SAFETY EVALUATION BY THE OFFICE OF NUCLEAR REACTOR REGULATION  
RELATED TO THE DECOMMISSIONING AND DISMANTLING OF FACILITY AND  
DISPOSITION OF COMPONENT PARTS

BRIGHAM YOUNG UNIVERSITY RESEARCH REACTOR

FACILITY LICENSE NO. R-109

DOCKET NO. 50-262

Figure 1 Cutaway of Core-Shield Assembly

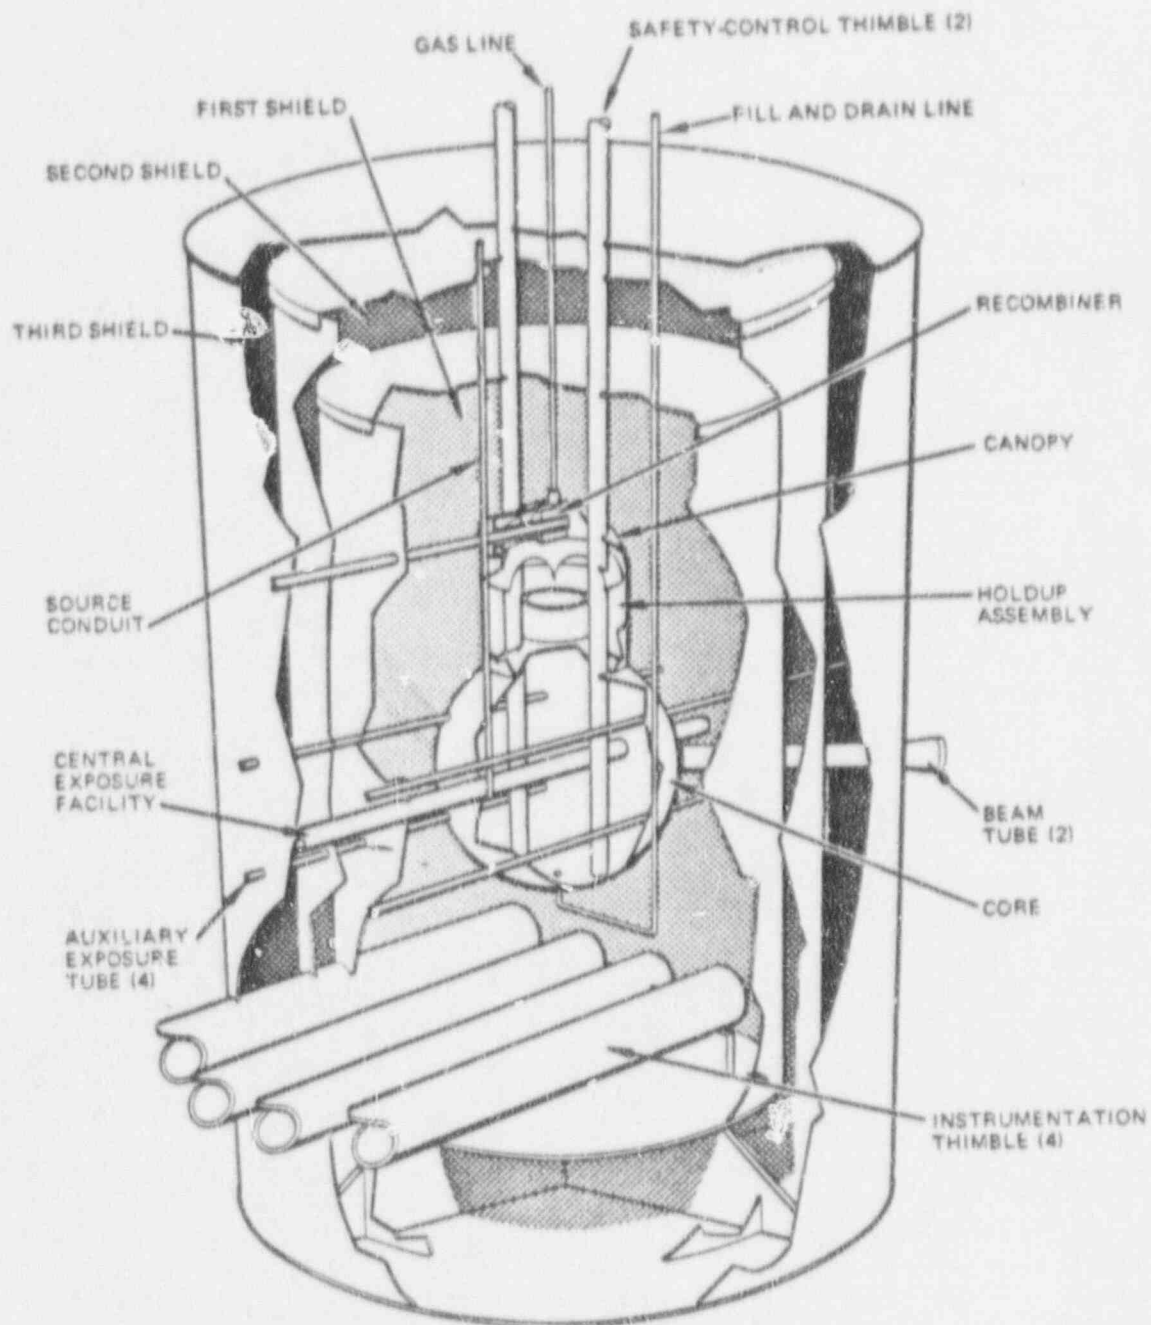
The current reactor configuration (Figure 1) includes the empty stainless steel core vessel, three layers of inner shield tanks, a water-filled outer shield tank, miscellaneous piping, a through-tube, beam tubes and auxiliary exposure tubes, and instrumentation thimbles. At this time, neutron activation of the impurities in the stainless steel components of the core vessel is estimated to be less than 20  $\mu\text{Ci}$  of long-lived radionuclides. No other significant radioactivities are known to exist.
